This response is provided on behalf of Canmoor Developments Ltd. To a second set of comments provided by the LLFA during the planning consultation period. The intention is to prevent a pre-commencement condition or negate the need for a condition if possible.

Enquiries to	Sarah Reghif	My reference	SWM/2025/0083
Direct Line		Your reference	APP/24/00606
Date	2 April 2025	Email	SWM.consultee@hants.gov.uk

**Demolition of existing buildings and redevelopment of the industrial site comprising of a single industrial building, split into three units having a flexible set of mixed industrial uses. This includes use classes E(g) (iii), B2 and B8 along with ancillary offices, car parking, yard areas, soft landscaping and associated infrastructure. at 8 Downley Road, Havant, PO9 2JD
(Application No. APP/24/00606**

PROPOSED DRAINAGE PLAN

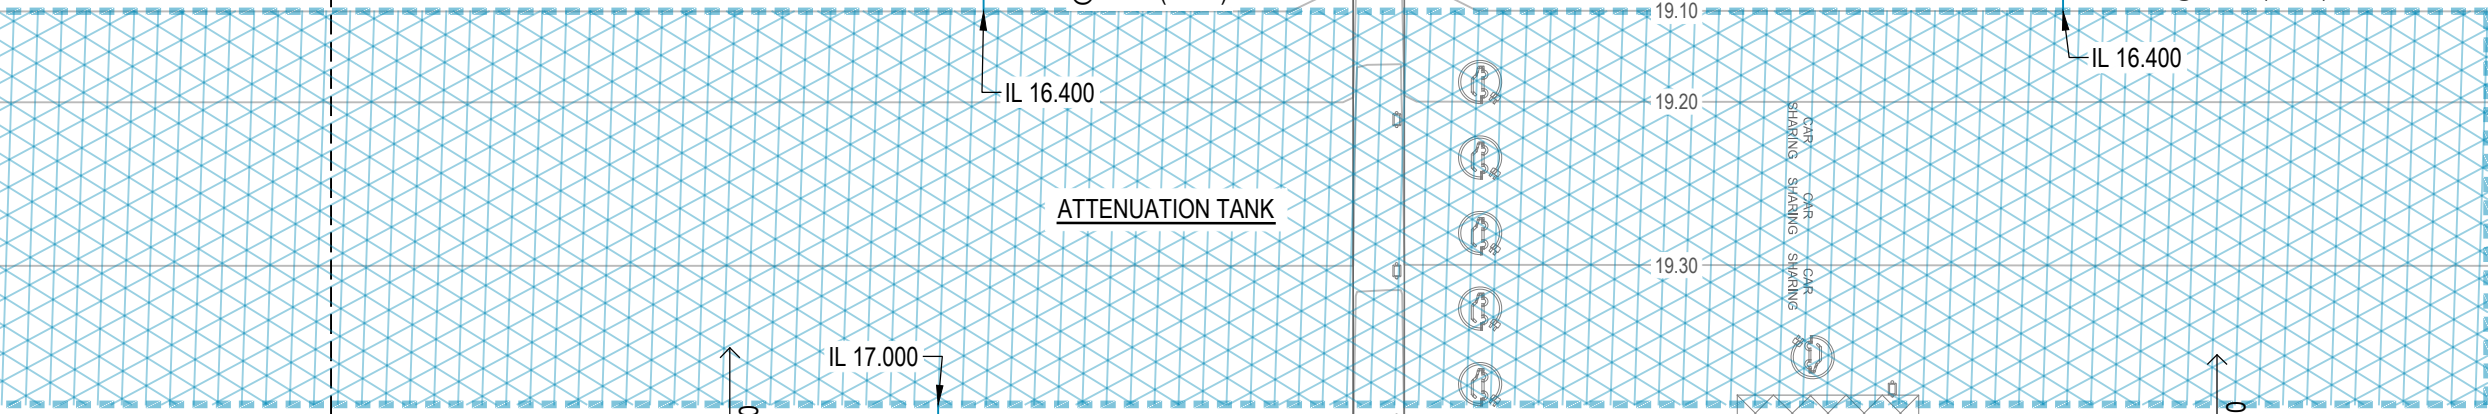
No groundwater monitoring has been undertaken so further evidence is required to demonstrate that any infiltration systems will have a 1m unsaturated area beneath their base.

Limited information has been provided in relation to site levels, drainage levels and exceedance flows however due to the nature of the site and available space, we would be willing to accept further information to be provided by condition.

Given that a previous design was provided identifying a discharge point to the surface water sewer, if the above information identifies elements such as high water tables preventing the proposals to function as required, an alternative is available. As such, we would be willing for additional information to be provided by condition and would recommend that the following is applied:

Latest readings confirm a standing groundwater level of 16.01m AOD which is less than 1m below the base of the soakaway 16.40m AOD. This appears to be an isolated case which is also not reflected within the logs. Regardless, based on the investigations a 1m unsaturated zone beneath the base of the tank is not achievable.

As a result of the above findings an updated strategy drawing has been included as Appendix C. This is based on discharge into the public surface water sewer and illustrates proposed site and drainage levels plus exceedance flows. Associated hydraulic calculations have also been included that can easily be cross referenced to the drawing.

AREA DRAINED 14,990m²
SIZE 83.5x13x1.2m (1,303m³)
WATER VOLUME 1,237m³
GROUND LEVEL 19.375m-19.100m
TANK TOP 17.600m
TANK BASE 16.400m

CHAMBER DIA 1.80m PCC RING OR GRP CHAMBER
CHAMBER CL 18.965m
LOWEST INLET LEVEL 16.373m
DISCHARGE RATE 5.80 l/s
PUMP TYPE DUTY/STANDBY
RISING MAIN L11m FROM 17.765m TO 17.426m. DIAMETER TO BE CONFIRMED BY SUPPLIER.
